SUBJECT: BEAVER VALLEY POWER STATION, UNIT NO. 1 (M98136)

Amendment No. 205  
License No. DPR-66

ATTACHMENT TO LICENSE AMENDMENT NO. 205

RELATED TO AMENDMENT NO. 205 LICENSE NOS. DPR-66

FIGURE 3.4-1

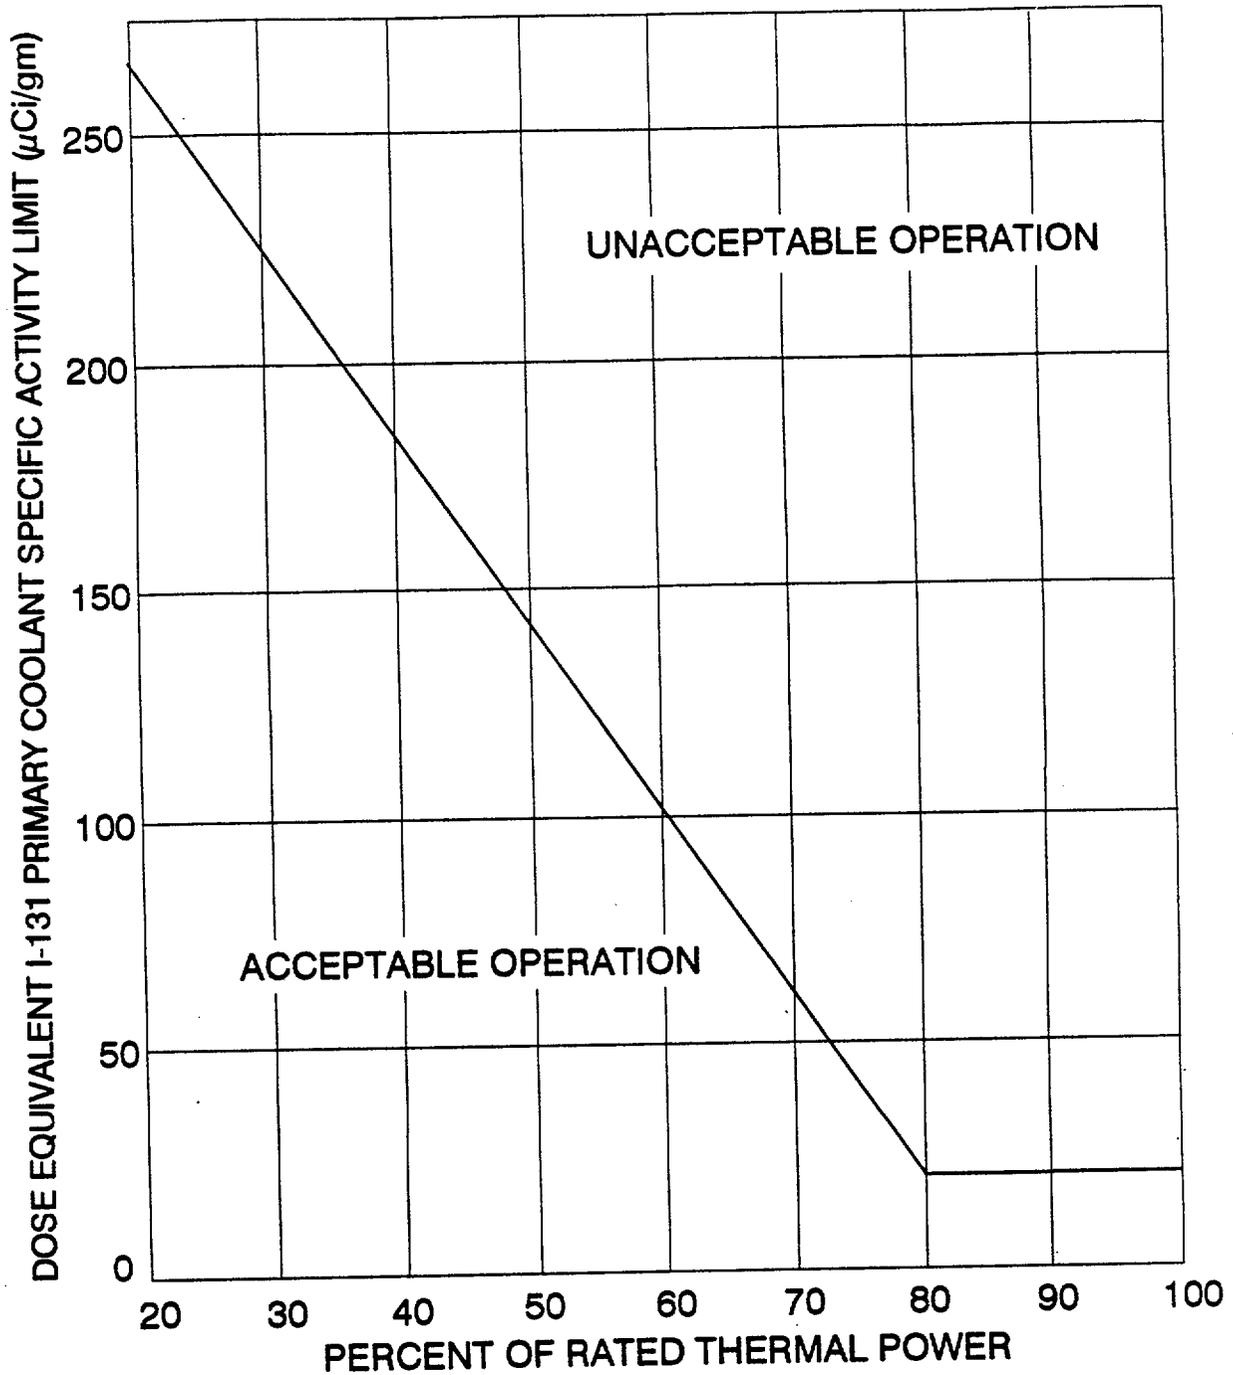
The amendment modifies the TSs by reducing the reactor coolant system specific activity limits in accordance with the NRC's guidance provided in Generic Letter 95-05, "Voltage-Based Repair Criteria for Westinghouse Steam Generator Tubes by Outside Diameter Stress Corrosion Cracking." The definition of DOSE EQUIVALENT I-131 is replaced with the Improved Standard TS definition in the first sentence and an equation is added based on dose conversion factors derived from the International Commission on Radiation Protection (ICRP) ICRP-30. TS 3.4.8, Specific Activity, is revised by reducing the DOSE EQUIVALENT I-131 limit from 1.0  $\mu\text{Ci}/\text{gram}$  to 0.35  $\mu\text{Ci}/\text{gram}$  for the 48-hour limit and from 60  $\mu\text{Ci}/\text{gram}$  to 21  $\mu\text{Ci}/\text{gram}$  for the maximum instantaneous limit. Item 4.a in TS Table 4.4-12, Primary Coolant Specific Activity Sample and Analysis Program, TS Figure 3.4-1, and the Bases for TS 3/4.4.8 are also modified to reflect the reduced DOSE EQUIVALENT I-131 limit.

- a. With the specific activity of the primary coolant  $> 0.35 \mu\text{Ci/gram DOSE EQUIVALENT I-131}$  for more than 48 hours during one continuous time interval or exceeding the limit line shown on Figure 3.4-1, be in HOT STANDBY with  $T_{\text{avg}} < 500^\circ\text{F}$  within 6 hours.
- b. With the specific activity of the primary coolant  $> 100/\bar{E} \mu\text{Ci/gram}$ , be in HOT STANDBY with  $T_{\text{avg}} < 500^\circ\text{F}$  within 6 hours.

The ACTION statement permitting POWER OPERATION to continue for limited time periods with the primary coolant's specific activity > 0.35  $\mu\text{Ci}/\text{gram}$  DOSE EQUIVALENT I-131, but within the allowable limit shown on Figure 3.4-1, accommodates possible iodine spiking phenomenon which may occur following changes in THERMAL POWER. Operation with specific activity levels exceeding 0.35  $\mu\text{Ci}/\text{gram}$  DOSE EQUIVALENT I-131 for more than 48 hours during one continuous time interval or exceeding the limits shown on Figure 3.4-1 must be restricted to ensure that assumptions made in the UFSAR accident analyses are not exceeded.
